Technical Guidance Committee

Meeting Minutes

Thursday, December 7, 2017

Trench Configuration – Plan View

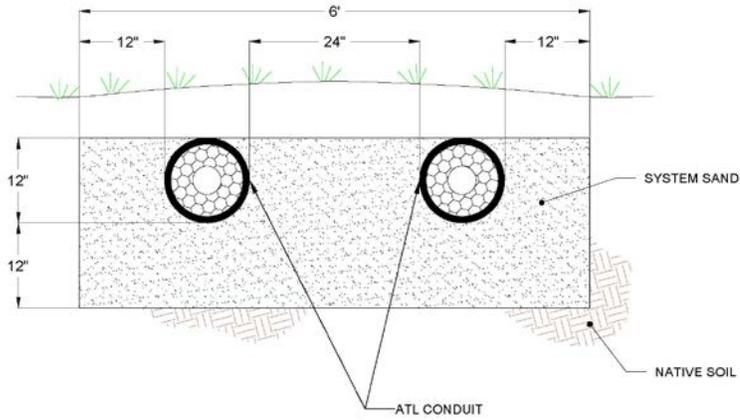
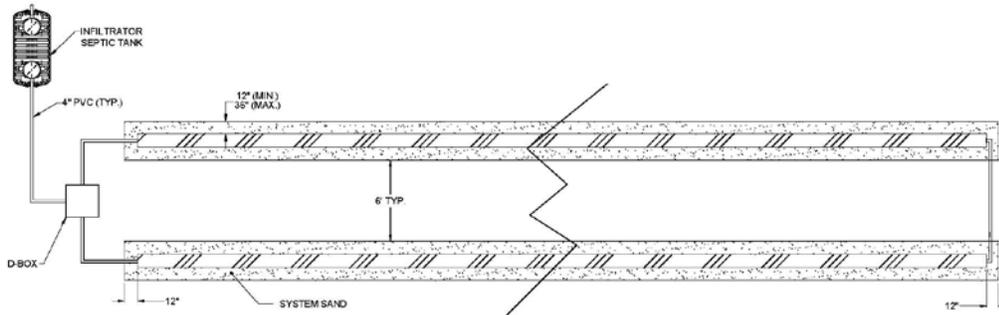
James Craft asked Dick Bachelder for a clearer trench configuration diagram on page 7. Dick Bachelder explains the difference between the two system diagrams and placement of sand. Mike Reno mentions on page 7 the plan view does not match the six foot wide trench. Dick Bachelder agreed and said it was a single plan. He also said he would enhance the resolution on the plan view diagrams on pages 7 and 8.

Bed Configuration – Plan View

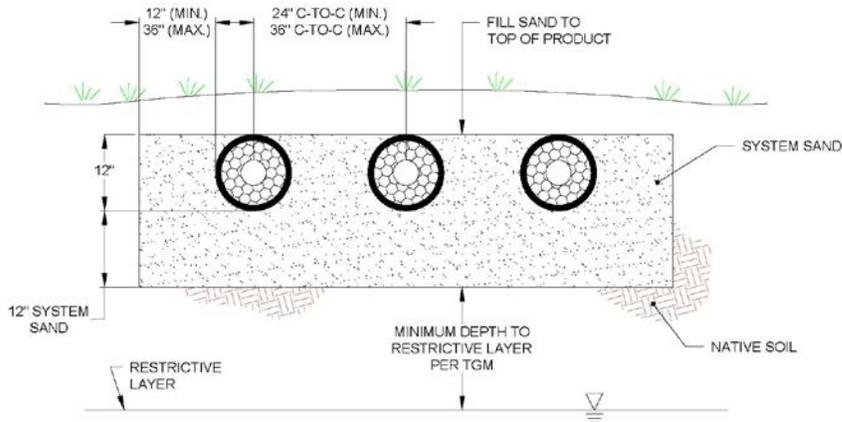
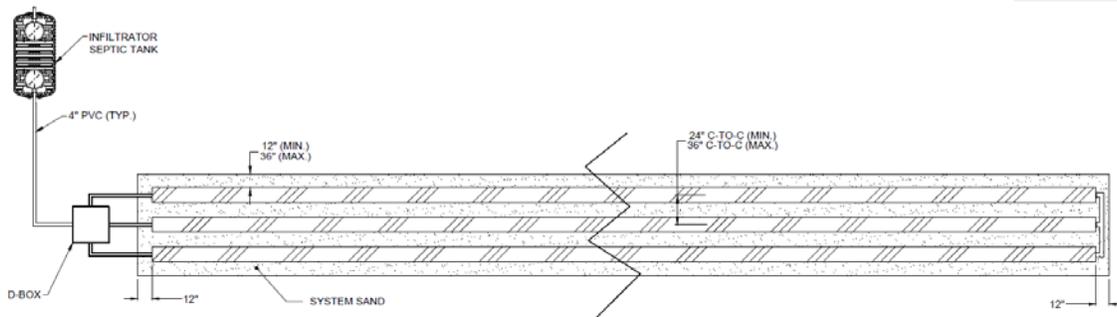
DEQ Letter Review #19, Infiltrator ATL Design Manual Page 8 Bed Configuration-Plan View:

James said, “Is the ATL pipe designed so that one pipe is filled with effluent before going to the next pipe? I want to have a blurb in the manual about having a distribution box to make sure the flow is distributed evenly throughout the system.” Mike Reno said, “Do we require a distribution box on anything else with just two pipes? I don’t think we require it for anything else.” James Craft asked TGC members on whether or not the ATL installation manual needed to include instructions about installing a distribution box. Dick Bachelder said, “My response is, and I feel strongly about this. The ATL system is nothing unique. I am trying to keep the manual to 24 pages. We are willing to consider complying with the request but want to understand why.” James Craft said, “It is a concern with even distribution of effluent between ATL conduits.” Dick Bachelder said, “We agree with the concern, we do not have to do this in other states. We are just reinforcing what you do in your TGM. All drawings include a distribution box. What do you want to say and I will put it in the manual.” Mike Reno said, “Say distribution box is recommended for installation.” Jason Peppin commented the TGC required the Presby AES system to have a distribution box. Dick Bachelder said he will send a revised draft of the installation manual to the TGC for further review with the TGM reference for a distribution box. Kellye Eager cited the TGM reference, 3.2.5.2 for Distribution box for Dick Bachelder.

Comment [BD1]: To DEQ/GC: Call out for vertical separation distance revised as requested.

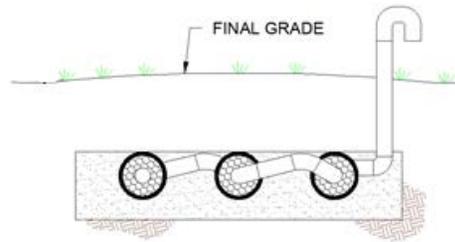
The interpretation of the diagram showing the raised connection was discussed. Dick Bachelder said, "The objective is to fill the ATL conduit before moving to the next row. The second diagram of the raised connection will need to be revised to reflect this objective." Dick Bachelder further explained from a manufacturing perspective we want to maximize first row but not fill it chock-full. Mostly we are concerned about air, for the aerobic conditions." Joe Canning asked how the ATL was tested. Dick Bachelder said, "It

Figure 1. Septic tank, recirc tank, and *LOWeFLOW* filter. Discharge tank not shown.

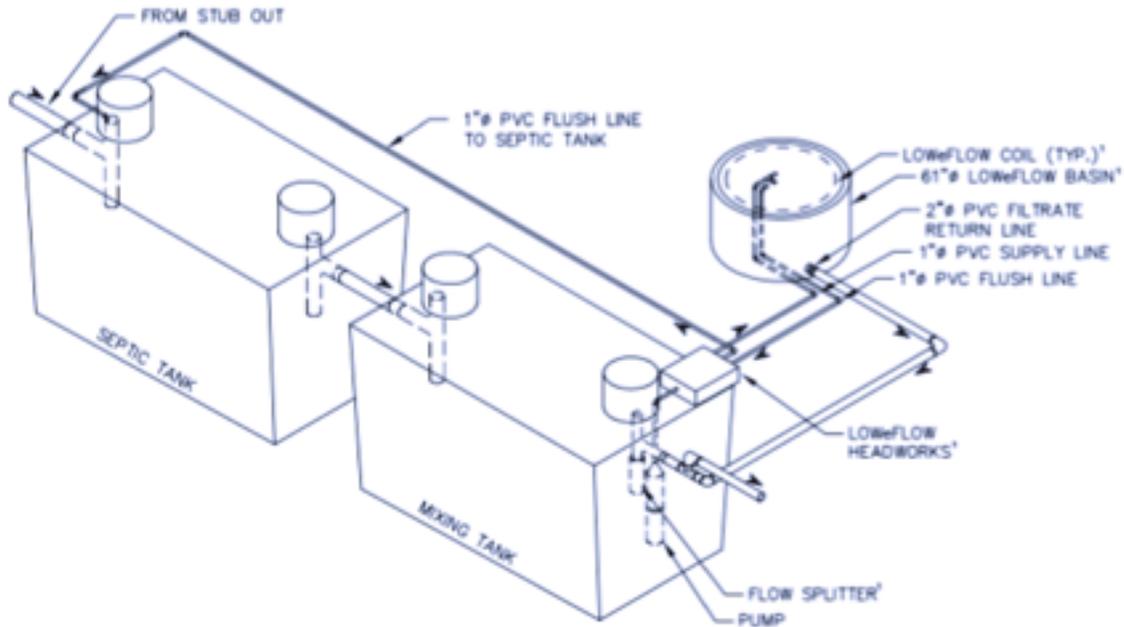
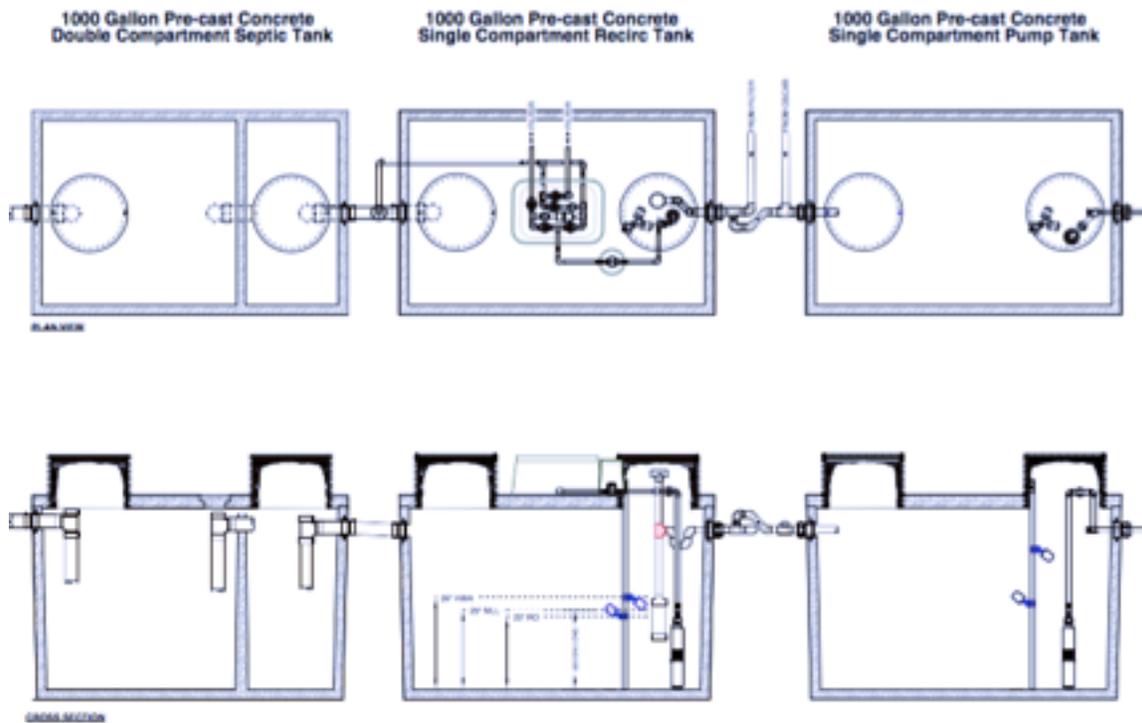
Joe Canning asked questions on Figure 1 on page 2 and why it did not show the discharge tank like it is shown on Figure 2. Dave said, “We did put ‘ discharge tank not shown’ in the Figure 1 description. I can make both the same if needed. I am happy to make one figure and combine those two for clarity.” Jason Peppin asked, “In a gravity situation would a third tank be involved?” Joe Canning asked, “What volume of tank are we looking for here.” Dave Lowe said, “I will make a figure or a
